January 19, 2016

**RE: *RXR Glen Isle Partners LLC - Waterfront Development Project
Rebuttal of Post Hearing Written Comments***

GARVIES POINT-EAST
ON-SITE PONDING - STORM EVENTS > 5"
1/16/2017
PS&S
SCALE: 1"=50'

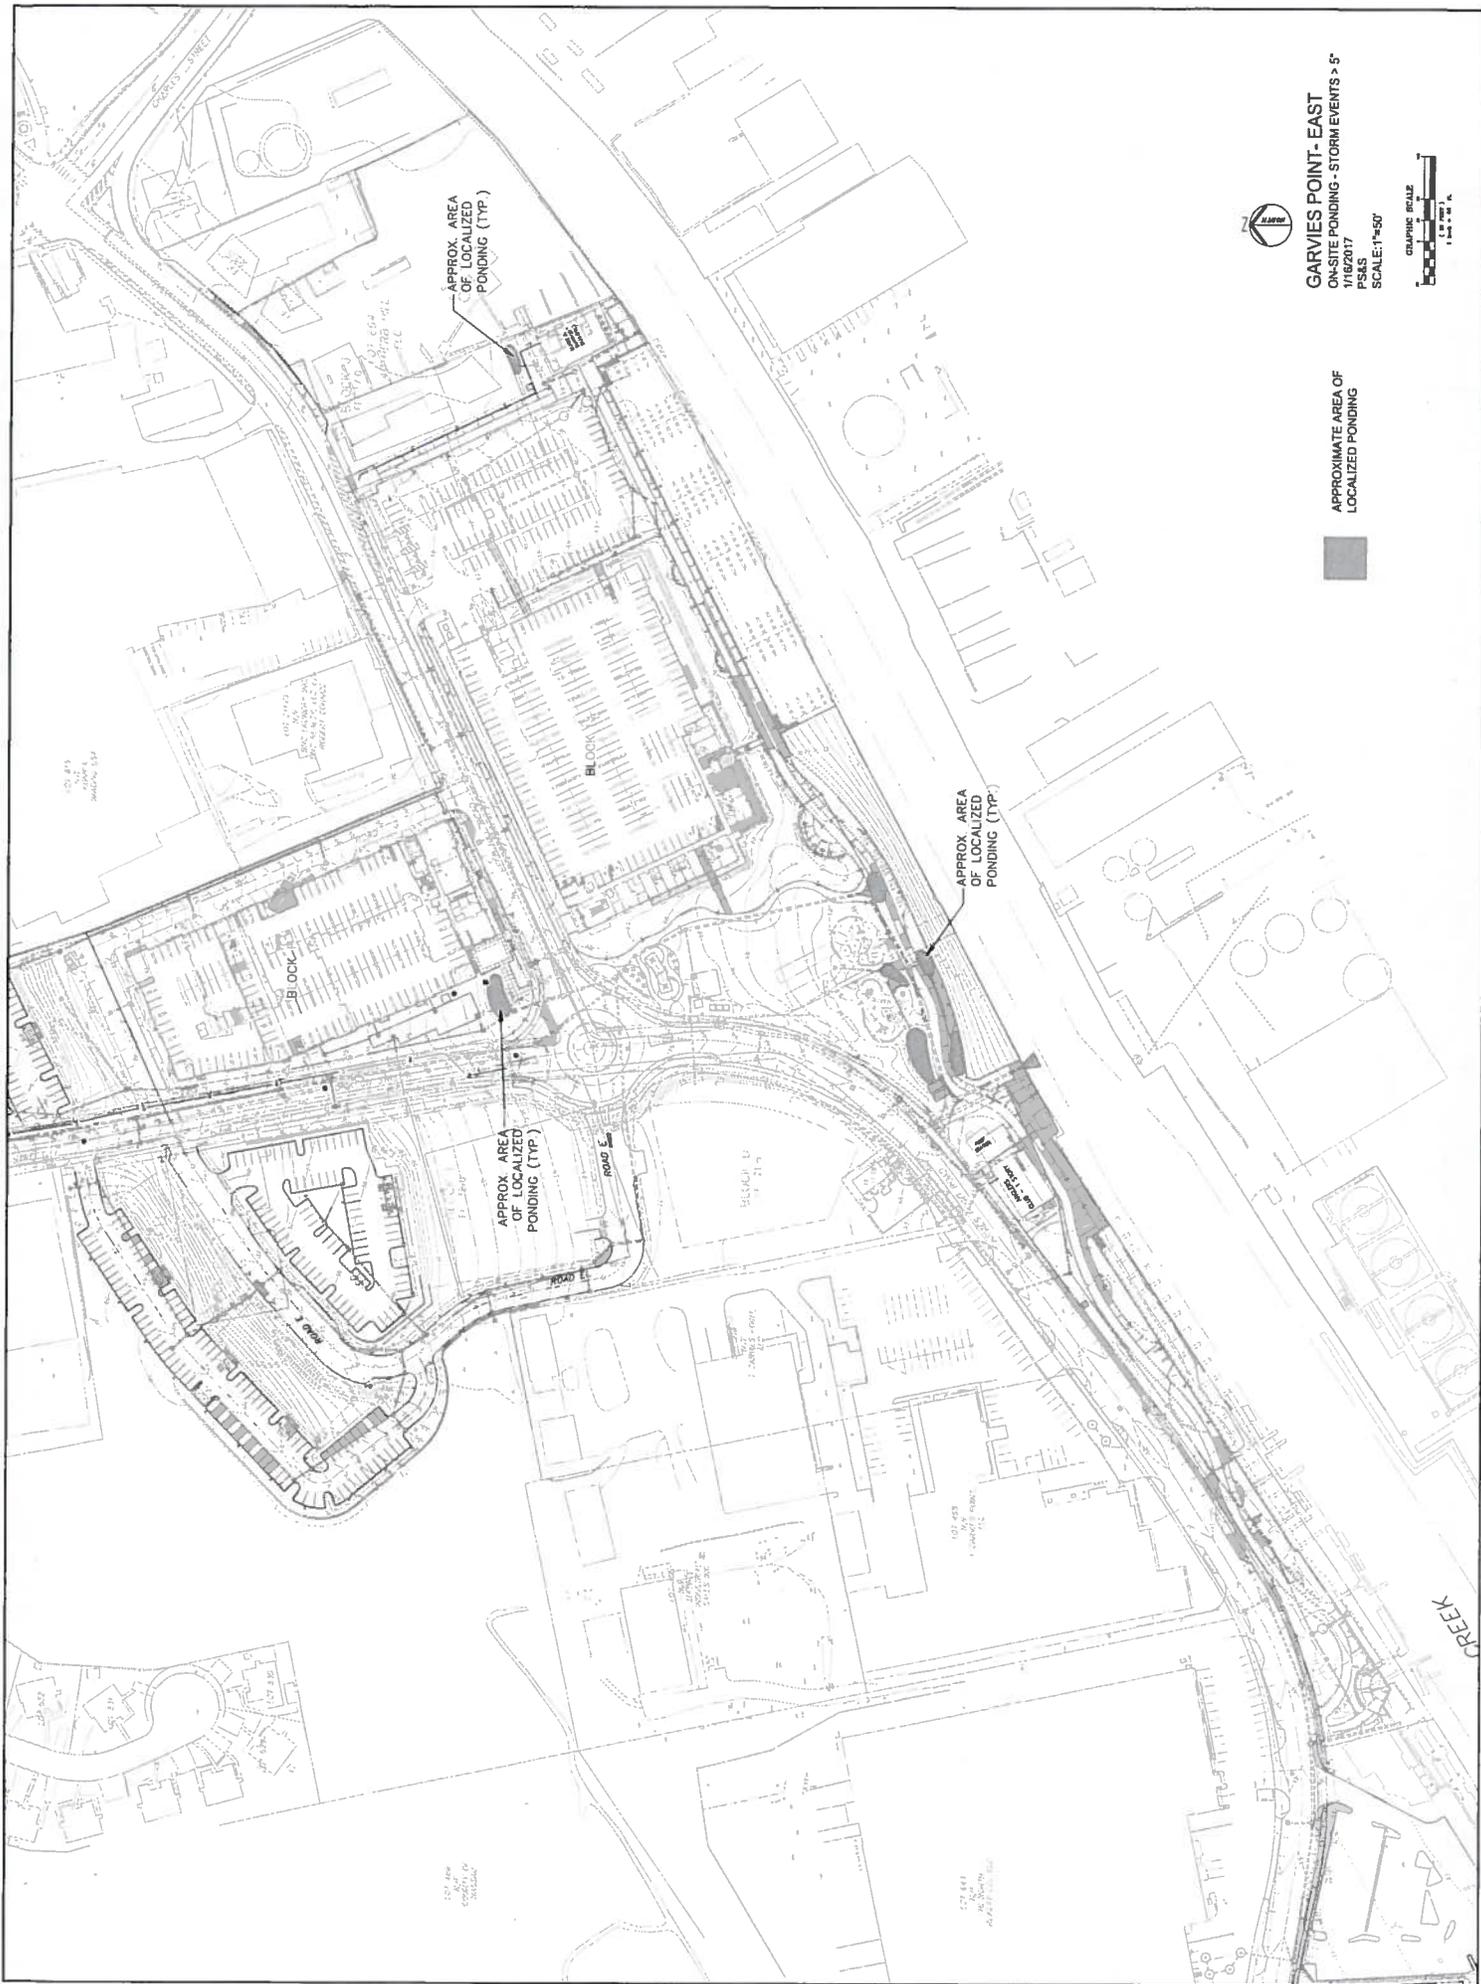
TOPIC AREA 5. Flooding. *“[W]hether the plan, despite the enhancements provided by the city’s consultant, could adequately address the risks cause by storm events that exceed 2 inches of rainfall.” The stormwater plan “does not include calculations of how severe this flooding will be.”*

RESPONSE: Several comments question the design of the stormwater system relative to storm events that exceed 2 inches. The stormwater system is designed to provide treatment for the 2” rainfall event, and will continue to collect and convey stormwater runoff from larger storm events. In accordance with Nassau County DPW standards, the conveyance system (piping) is designed for 4.8” of runoff, which equates to slightly less than the NYSDEC 10-year storm event. For storm events less than 5”, stormwater runoff is collected and conveyed in the storm sewer systems, with 2” of the runoff conveyed through the water quality treatment devices before discharging to the creek. During storms with greater than 5” of rainfall (which have a frequency of occurring once every ten or more years), there may be instances where stormwater may pond at some localized low points on site because the pipe systems were not designed to convey these larger storm events. The areas of localized on-site ponding during these extraordinary storm events (greater than 5”) include the biofiltration garden in Renaissance Park, several low points along the esplanade in Renaissance Park, the biofiltration garden adjacent to Building H and the biofiltration garden in Garvies Point Park (it is expected that the biofiltration gardens would temporarily pond water as this is how they are designed and function). The attached exhibits entitled Garvies Point East On-site Ponding – Storm Events >5” and Garvies Point West – On-site Ponding – Storm Events >5”, dated 1/16/2017 show the approximate worst case limits of this localized ponding for storm events greater than 5” and when the in-line check valves are in the closed position (due to an extreme coastal flooding condition where the outfall pipes are fully submerged). This localized flooding is expected to begin receding as soon as the intensity of the storm event reduces and the rate of stormwater flow is at or below the design flow of the stormwater system (5” storm). It is important to note that the water quality treatment devices will continue to treat a minimum of 2” of stormwater runoff, even during storm events that are larger than 2” or greater.

In the case of severe wind driven coastal flooding conditions (i.e., hurricane or significant nor’easter) when water from the adjacent Creek may overtop certain areas of the development site and pond at low points, it is important to note that the proposed project site has been raised as high as practicable in order to address this potential coastal flooding condition. There are several low points along the proposed esplanade where the 100-year coastal flooding condition may overtop the proposed bulkhead and /or shoreline and create areas of localized ponding on the development site including low points within Renaissance Park, Garvies Point Park and Sunset Park as well as along Crescent Park. By raising the site, the areas of proposed ponding during a coastal flooding condition have been reduced significantly on the site: more areas of the development site are prone to coastal flooding today (existing conditions) as compared with the proposed development conditions.
